# Access Compliance Report

## Public Rights-of-Way

Intersection ID: 48496	Main Street: LOCH_LOMOND_DR	Cross Street: CASTLECOVE_RD	Location:	S
ADA ID: B023FD739557	Ramp Type: Perp	Initial Pass/Fail: Fail	Overall Compliance: No	Severity Score: 25
Codes/Mitigation Info/Possible Solution		Field Measurements/Component Compliance

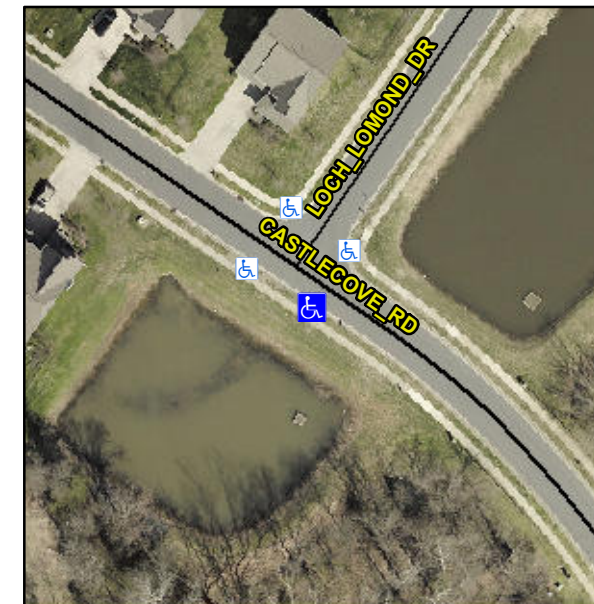
**Not Found, R304.2.2**

Compliance	Description	Data	Compliance	Description	Data
N/A	Ramp Length (in)	48.0	No	Ramp Slope (%)	15.1
Yes	Ramp Width (in)	48.0	Yes	Ramp XSlope (%)	2.0
N/A	Flare Type LT	N/A	N/A	Flare Type RT	N/A
N/A	Flare Slope LT (%)	N/A	N/A	Flare Slope RT (%)	N/A
N/A	Flare Traversable LT?	N/A	N/A	Flare Traversable RT?	N/A
N/A	Landing Length (in)	N/A	N/A	DWS Provided?	N/A
N/A	Landing Width (in)	N/A	N/A	DWS Contrast?	N/A
N/A	Landing Slope (%)	N/A	N/A	DWS Length (in)	N/A
N/A	Landing X Slope (%)	N/A	N/A	DWS Full Width?	N/A
N/A	Landing Curb? (Y/N)	N/A	N/A	DWS Offset (in)	N/A
N/A	Shared Landing?	N/A			
N/A	Gutter Ponding?	N/A	N/A	Gutter Slope (%)	N/A
N/A	Gutter Lip Ht (in)	N/A	N/A	Gutter X Slope (%)	N/A
N/A	Painted X Walk1?	No	N/A	Painted X Walk2?	N/A
	X Walk 1 Direction	To NE		X Walk 2 Direction	N/A
N/A	X Walk 1 Width (in)	N/A	N/A	X Walk 2 Width (in)	N/A
	X Walk 1 Slope (%)	2.9		X Walk 2 Slope (%)	N/A
	X Walk 1 X Slope (%)	1.5		X Walk 2 X Slope (%)	N/A

**Remove & Replace Entire Ramp.**
